APP-2020203164.01 – Grenadier Limited – Further Information

ENGINEERING REPORT - Resource Consent
765 MUHUNOA WEST ROAD
ŌHAU

CLIENT GRENADIER LIMITED - September 2021, Revision 2

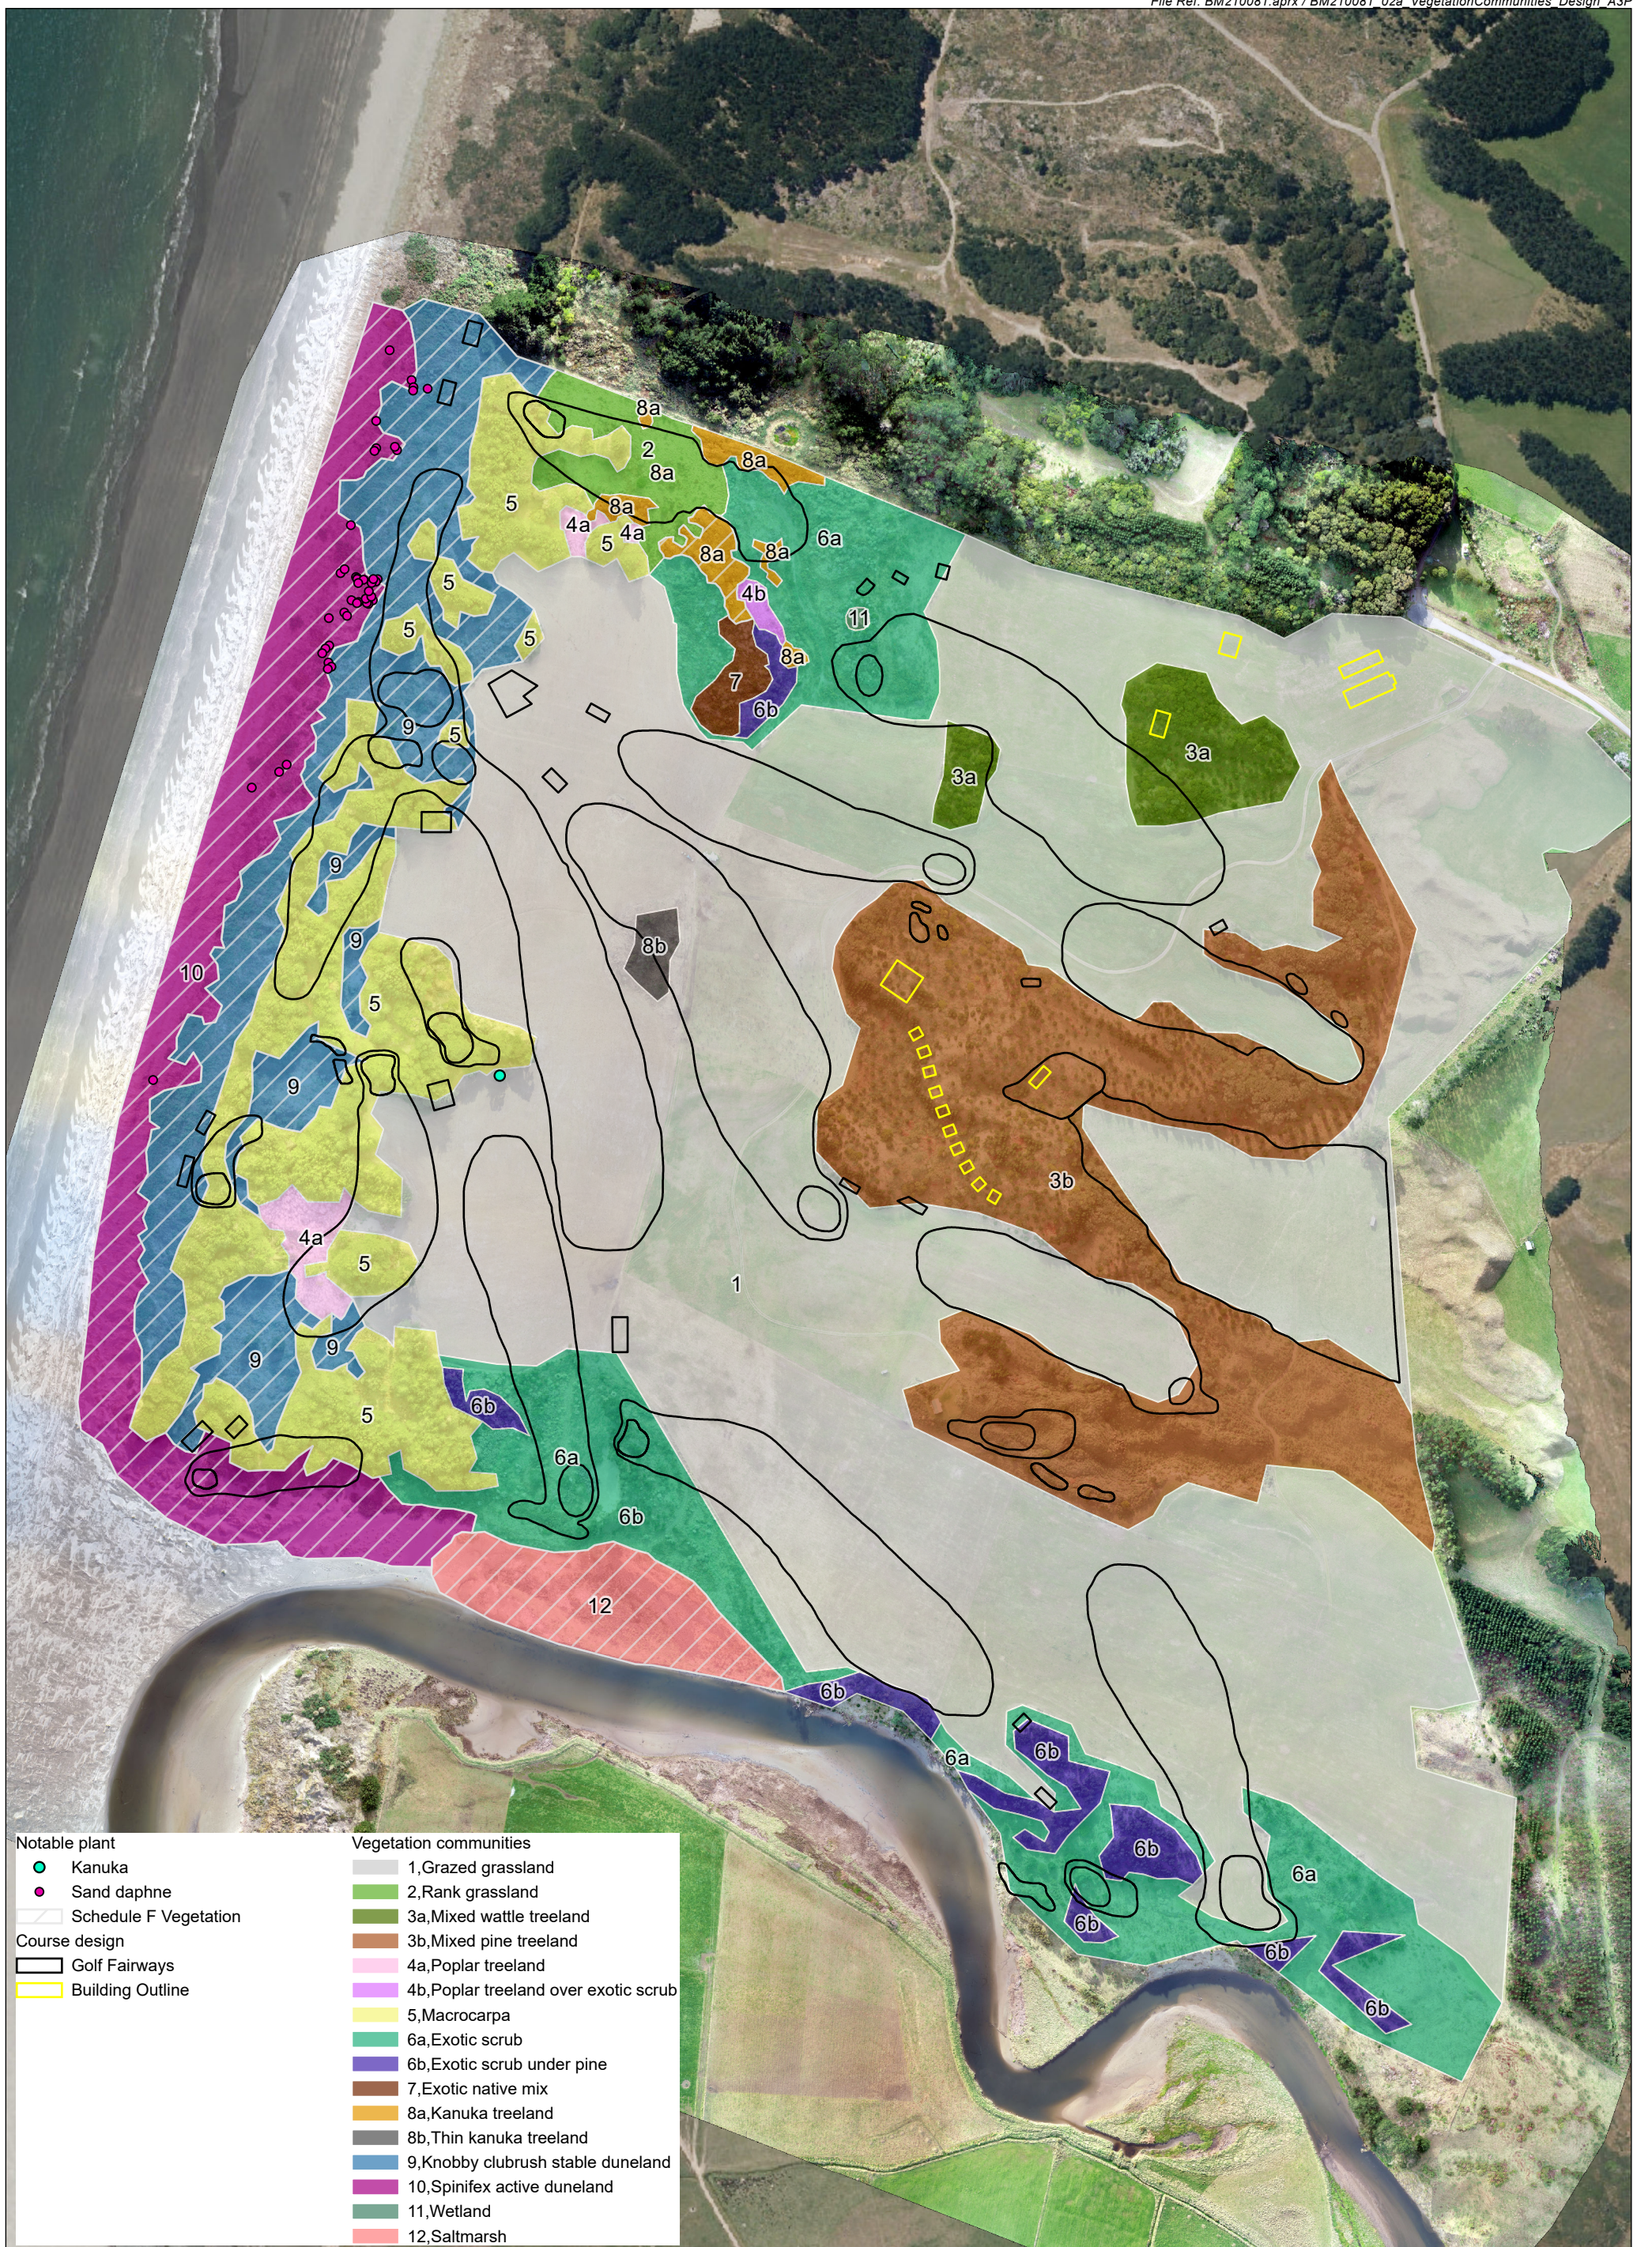
7. Please provide a map that overlays the areas proposed for vegetation clearance/earthworks with areas of rare and threatened ecosystems. It does appear that some of the holes proposed (specifically hole three) appears to remove a portion of a Schedule F area of Kanuka. Please provide a map combining both sets of information

14. Please provide further information that demonstrates that the location of hole 4 and 17 will not result in the loss of the dominate cluster of sand daphne within the site.

We apologise and appreciate the question. The required map was produced but it clearly did not get attached as the replacement for Map three in Appendix 1 as was intended. It is attached to this document.

On the matter of kanuka, we understand that while the fairway does show inclusion of areas of the kanuka, we understand, and as evidenced in our AEE, that the main stands of kanuka areas are not being cleared or otherwise impacted and the fairway will operate around those areas.

The maps in the AEE appendix show the sand daphne that were located in the botanic survey. The vegetation map and golf layout overlay attached to this response illustrates this more clearly.
